SUBJECT: Donald C. Cook Nuclear Plant Unit 1 and Unit 2
Docket Nos.: 50-315 and 50-316
Response to Request for Additional Information Regarding Proposed Amendment
Involving Thermowell Mounted Temperature Detectors (TAC Nos. MD3462 and
MD3462)

Response to Request for Additional Information

SKETCH OF THERMOWELL AND MODIFIED RCS HOT LEG RTD SCOOP

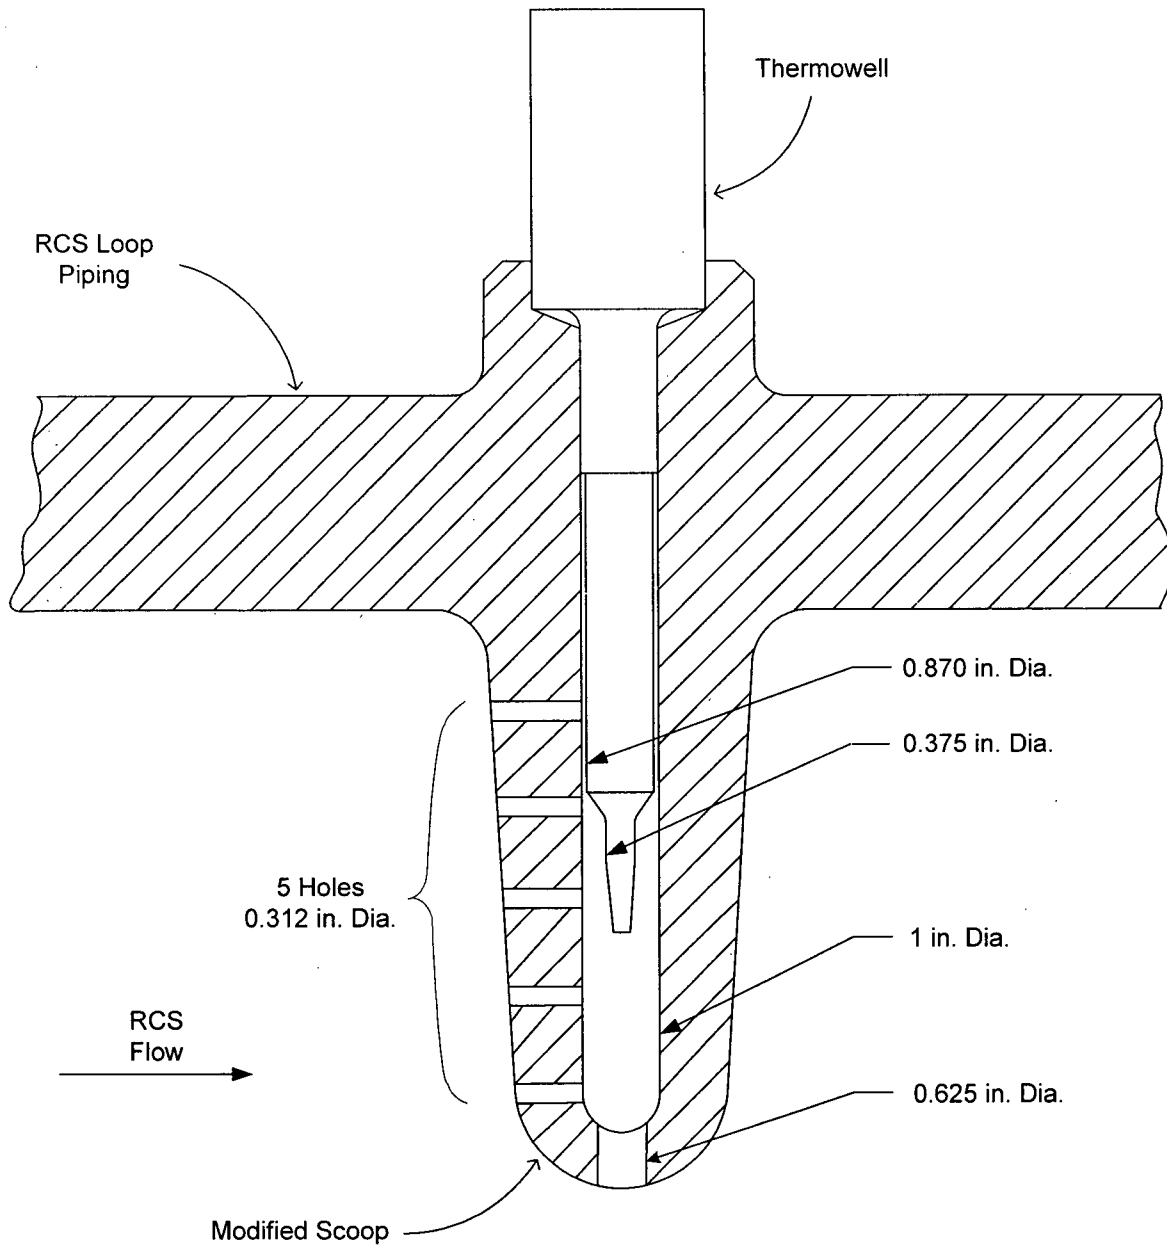
Enclosure 2, Section 3.0, states that the three hot-leg scoops in each reactor coolant system (RCS) loop will be modified to accept the new thermowells, which will contain the new, fast-response RTDs and that a hole will be drilled through the end of each scoop to facilitate flow past the RTD. How large is the drilled exit hole in comparison to the scoop's water-entry cross-section size? How was it determined that this exit hole size was sufficient to not cause reduced flow through the scoop that could potentially add to a delay in the response time of the measurement of RCS temperature changes or even introduce another uncertainty in the measurement?

The nominal dimensions of the exit hole, the holes that comprise the scoop's water-entry cross-section, the scoop inside diameter, and key thermowell diameters are shown on the attached sketch. These dimensions are standard for Westinghouse four loop plants that have performed the RTD bypass removal plant modification.

To determine the appropriate dimension for the exit hole, Westinghouse performed a test with an RTD in a scoop located in a piping loop with a pump capable of producing a water velocity of 50 feet per second approaching the scoop. A velocity of 50 feet per second is the nominal hot leg reactor coolant velocity. Since the actual hot leg velocity is greater than 50 feet per second, the actual response time is less. A bypass system was arranged to produce a rapid temperature change in the water flowing past the scoop. The temperature transient measured by the RTD was compared with the temperature transient measured by a detector just upstream of the scoop to define the response time difference for the RTD inside the scoop. Several scoop hole sizes were tested, and 0.625 inch diameter was selected as providing the optimal flow characteristics. The test results indicated that the response time of the new system with a thermowell RTD located inside a scoop was less than the response time allowance considered in the safety analysis for the new system. Response time tests at other plants performed after installing the new system confirmed that the actual response time was within the safety analysis allowance.
